Staff Report

Meeting Date: October 12, 2023 (Prepared October 5, 2023)

Item: DR 23-03, PLA 23-03, SA 23-02, & VAR 23-05 "Commerce Way Industrial Park" at 1414 Commerce Way

SHEET TITLE:
EXISTING PARCEL
CONFIGURATION
AND EASEMENT
PLAN

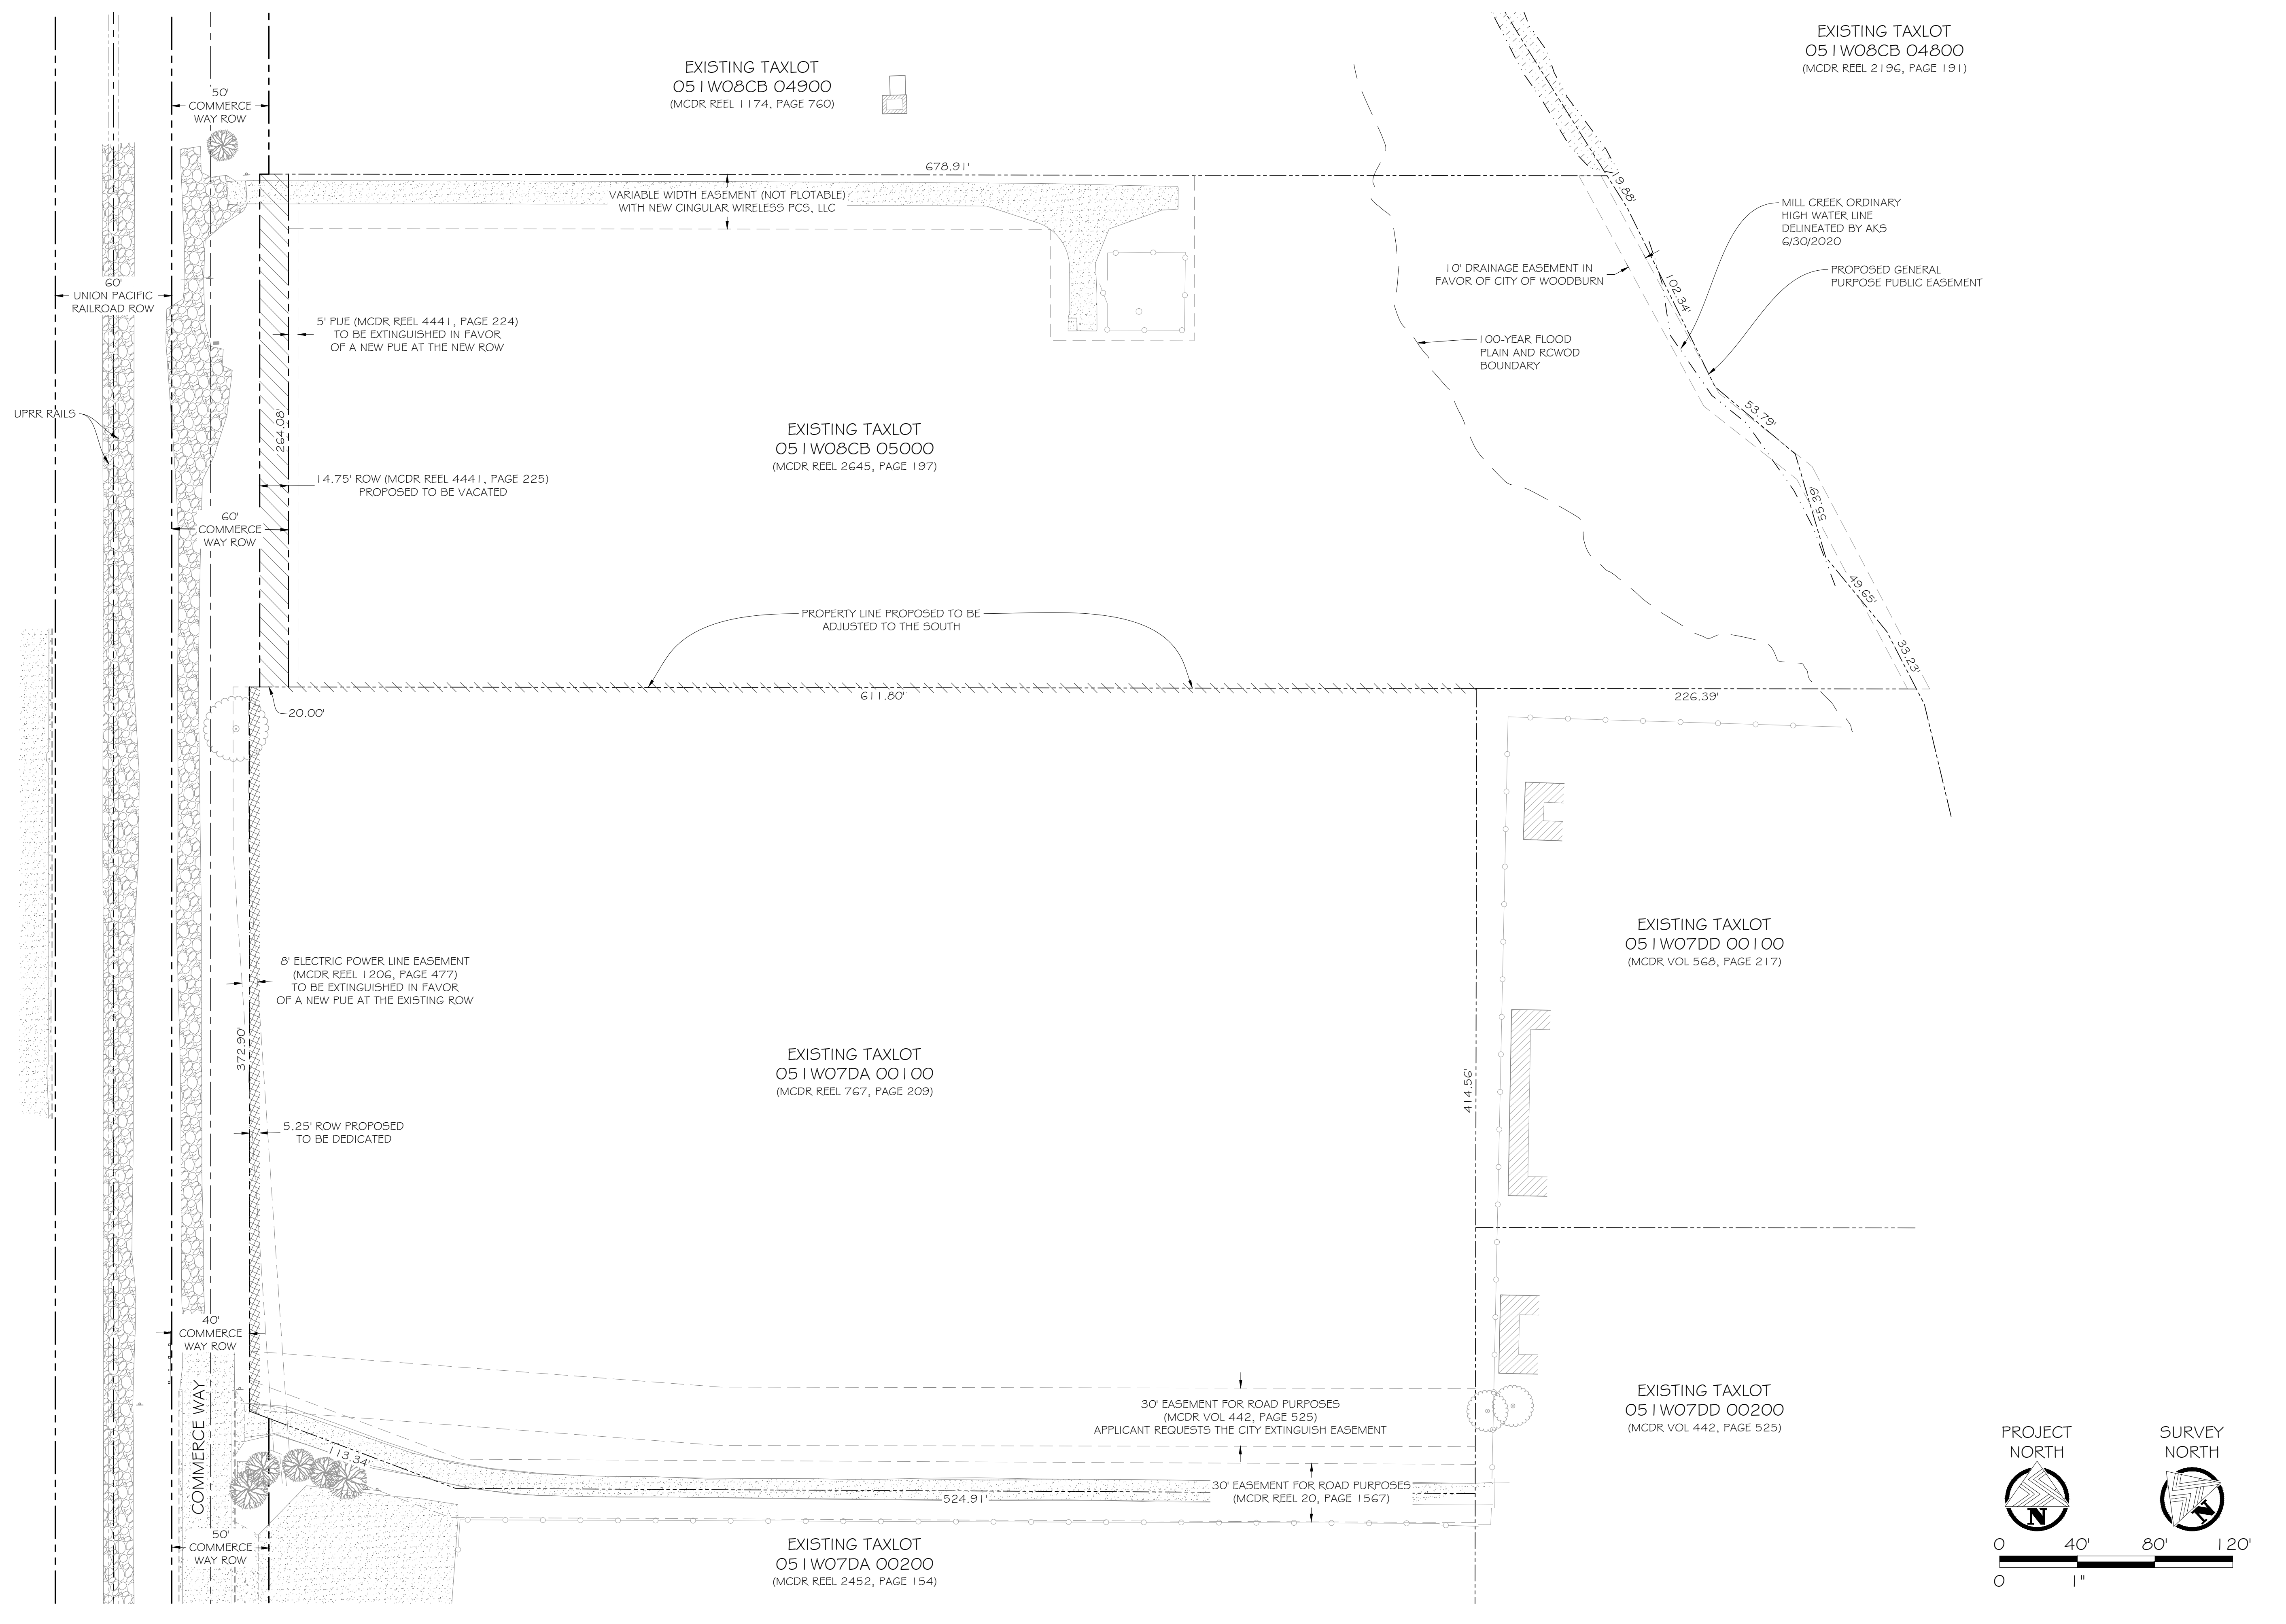
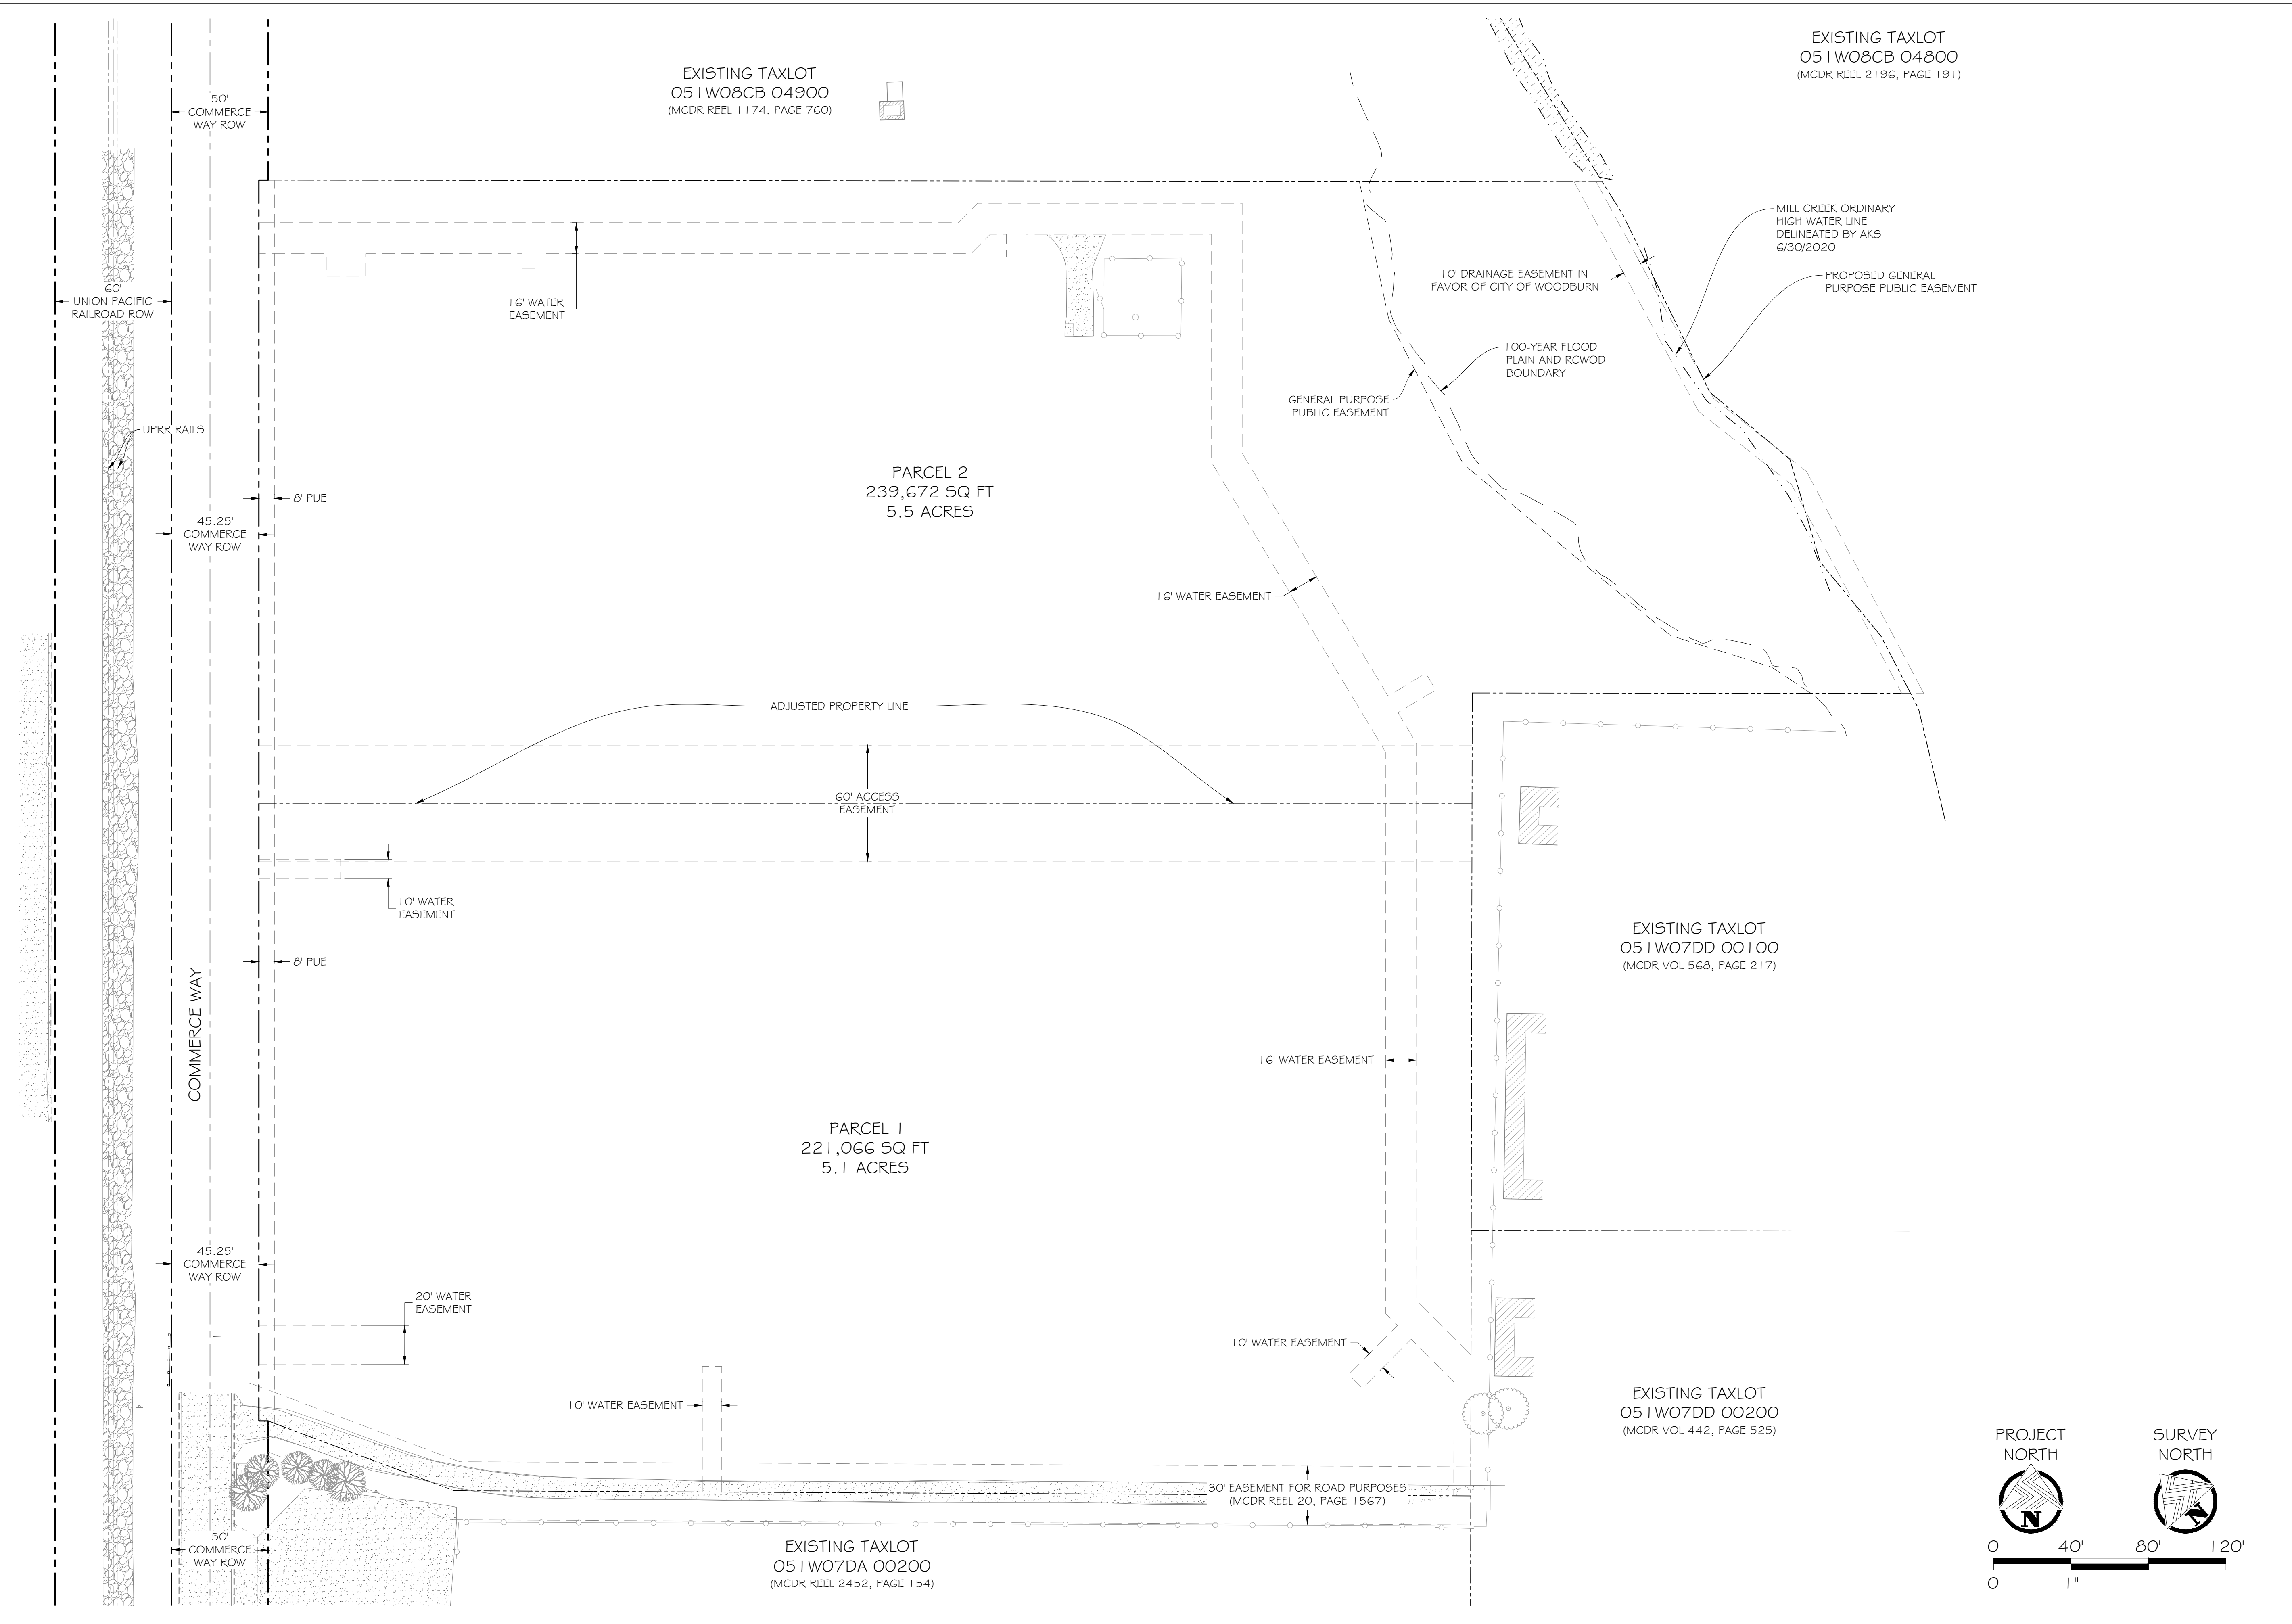
8. **Right-of-way dedication:** Developer shall dedicate Commerce Way right-of-way for Tax Lot 100, as illustrated on Sheet C-1.03. Dedication would occur concurrently with recordation of the property line adjustment.

10. Vacation requests: Application materials illustrate and note certain vacations being requested (see Sheet C-1.03). Prior to recordation of the property line adjustment and prior to civil plans approval for public improvements, the developer shall successfully complete the vacation process for the following:
 - a. The requested right-of-way along Tax Lot 5000; and
 - b. The requested 30-foot-wide easement within Tax Lot 100 (MCDR Volume 442, Page 525).

C-1.05

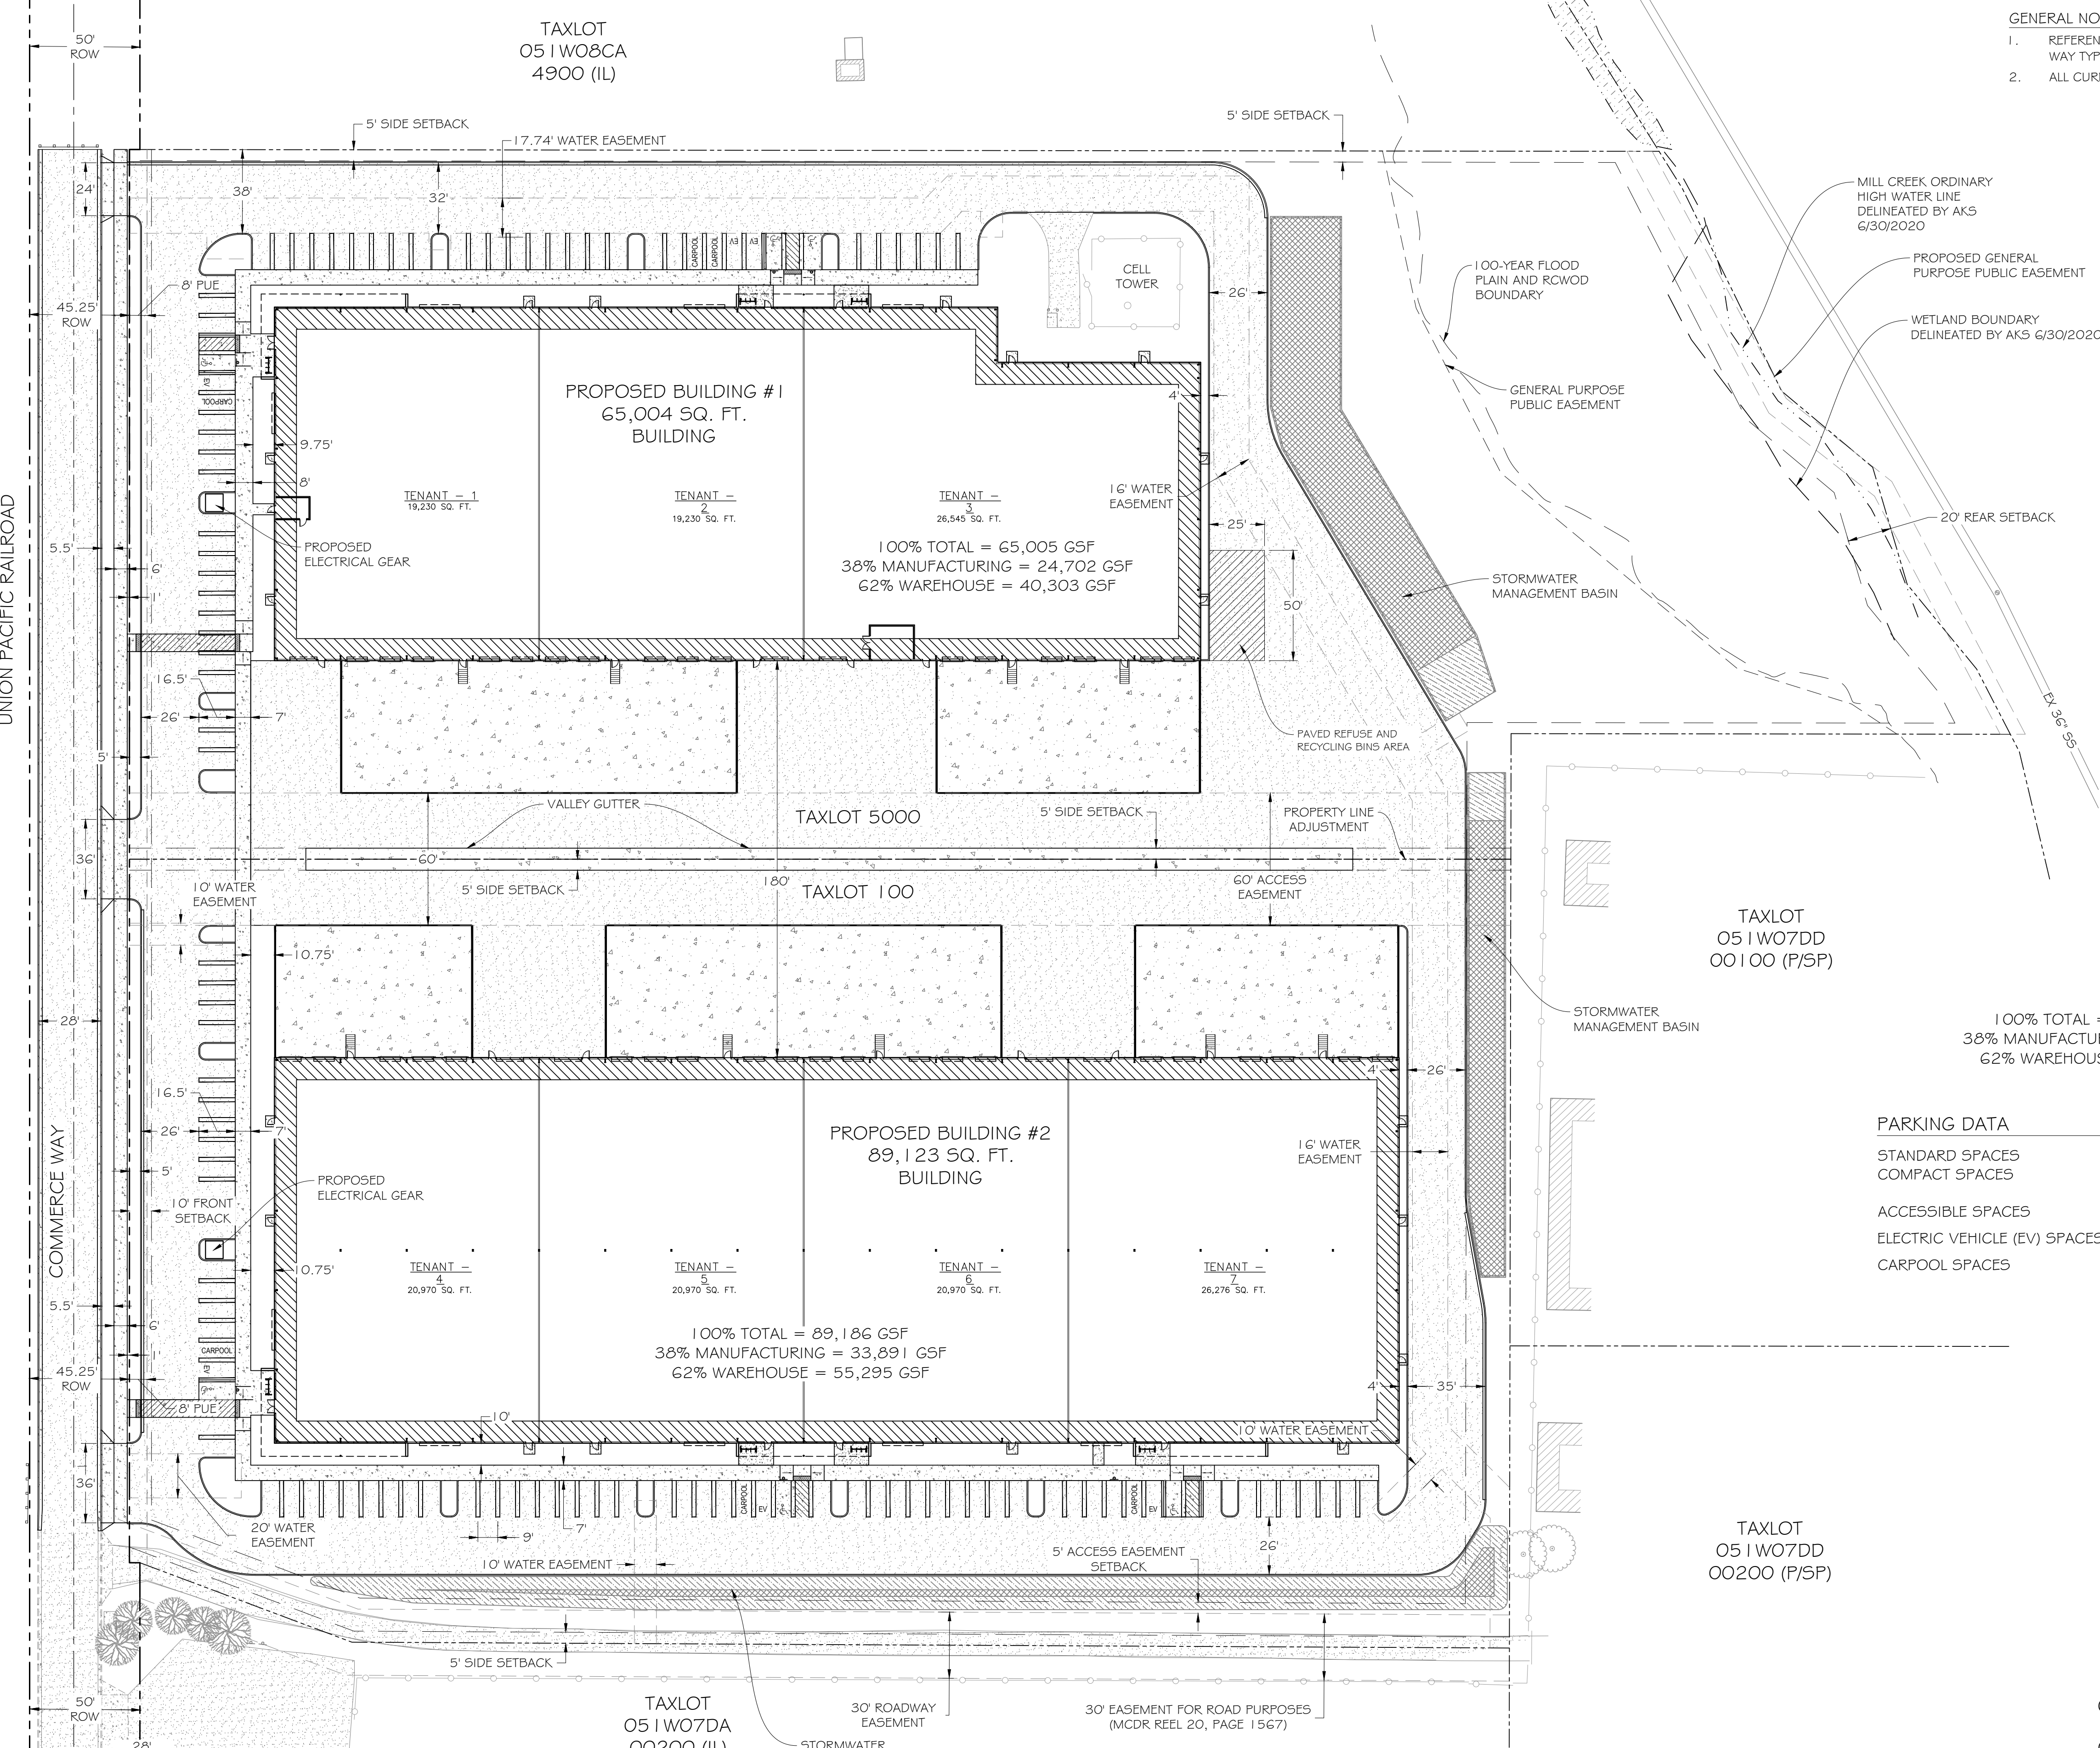
- a. Streetside public utility easements: To meet 3.02.01B & F2, an 8-foot-wide streetside public utility easement along the site frontage of Commerce Way as illustrated on Sheet C-1.05.
